BAR Meeting
September 16, 2015

ISSUE: New Construction: Townhouses

LOCATION: 2 Duke Street

BAR 2015-0268

BUILDINGS 06 & 09 OVERALL ELEVATIONS

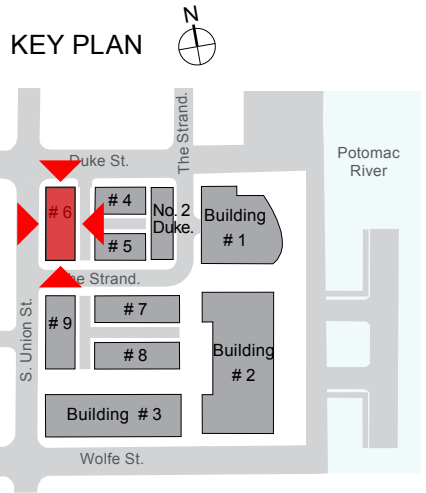
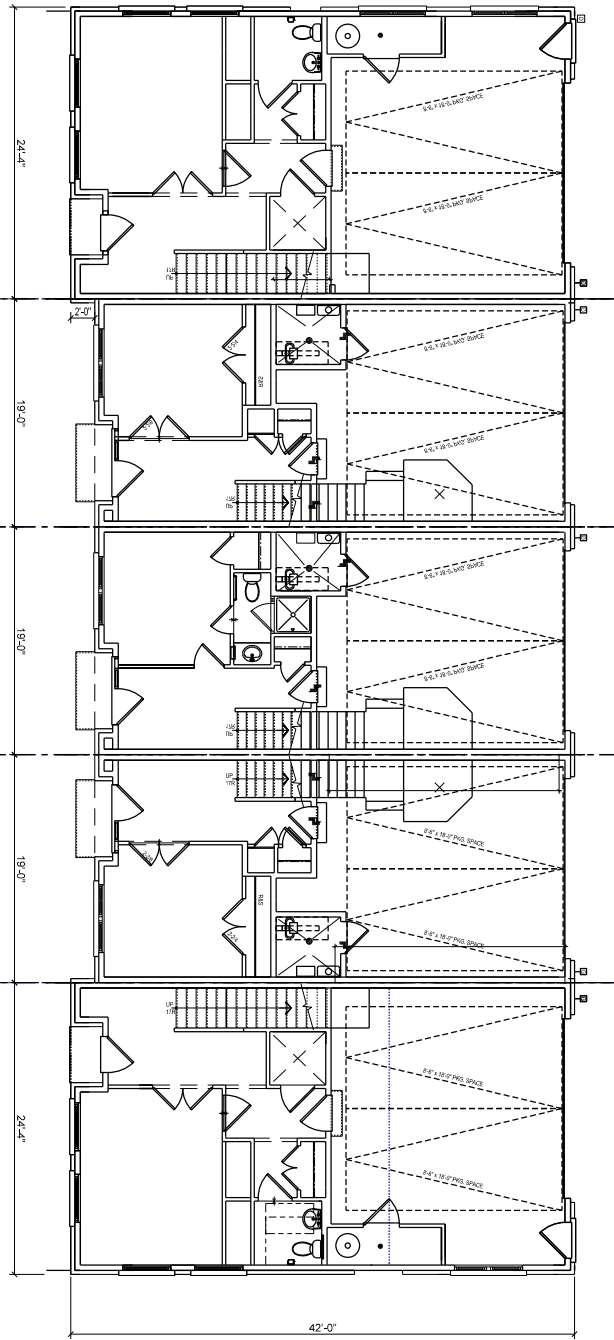
Ms. Finnigan stated that she was confused about the two different sets of drawings and additional freehand sketches. She supported the industrial appearance of Buildings 6 and 9 but that the north elevation of Building 6 was perhaps too much brick. She agreed with the direction of the staff recommendations shown in the sketches.

Ms. Roberts agreed that the design has come a long way. She liked Buildings 6 and 9 because they harken to iconic industrial buildings in Alexandria but thought the roof was still too flat. Regarding Building 4, she was thrilled that the applied bays had been removed and thought the revised sketch appeared more organic. She appreciated the precedent images and liked the changes to the windows. She liked the concept of a *piano nobile*. She expressed concern about the top floor and did not want this element to appear like a box plopped on top. She suggested the materials of the building could extend to the top. She agreed that Duke Street was the most successful but excited about the changes to the interior units. Regarding Building 5, she felt uneasy about the fourth story but liked the precedent buildings shown. She appreciated a design that was strong and respectful but not replicative. She thought that Building 7 was a very successful string and liked the more natural bays. She said that Building 8 was not her favorite and suggested exaggerating the bays to strengthen and get a more organic rhythm.

DETAIL PLANS AND ELEVATIONS

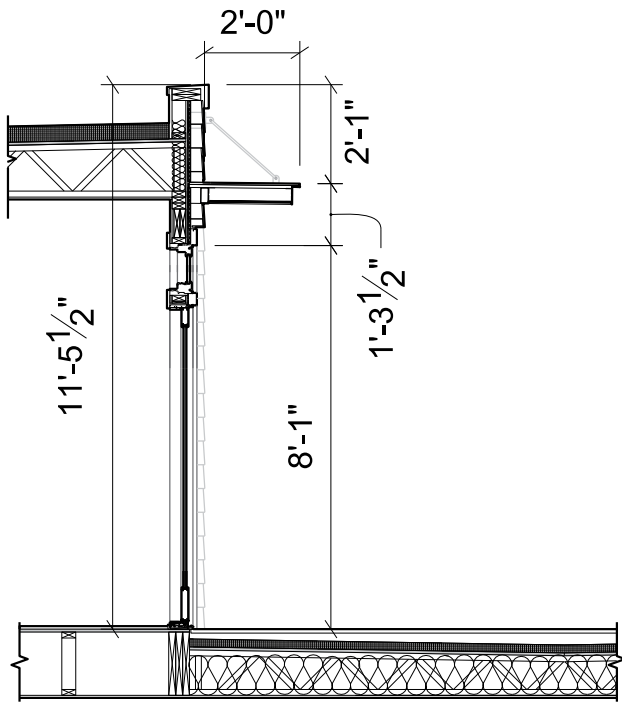
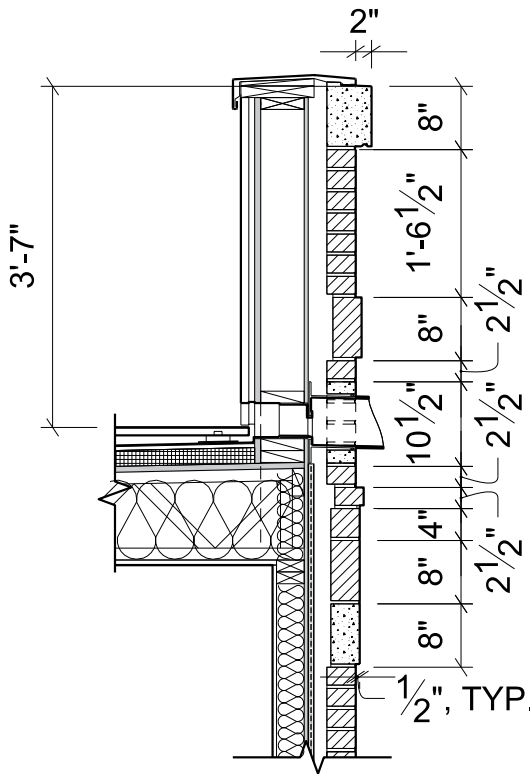
There are a number of locations where a metal panel is proposed beneath windows, such as shown in the detail on Sheet 28. Staff recommends either raising the sill or enlarging the window to eliminate the panel. There may be some places where the metal panel at the windows or a metal spandrel is appropriate, but those should be intentional and used to enhance variety between buildings. Some of the window drawings show slightly off balanced muntin placement which suggests that the window light configuration will not be balanced, such as in the details on

Sheet 28. Staff assumes that this is a drafting error and not an intentional design condition and recommends that future submissions correct this. The metal railings and balconies provide opportunities to showcase a richness of material and craftsmanship as well as convey the residential character of these buildings. This element should continue to be refined and offers an opportunity to provide variety. The applicant should show the proposed locations and number of vents and utilities on all elevations. These should be limited to the rear elevations and appropriately located.
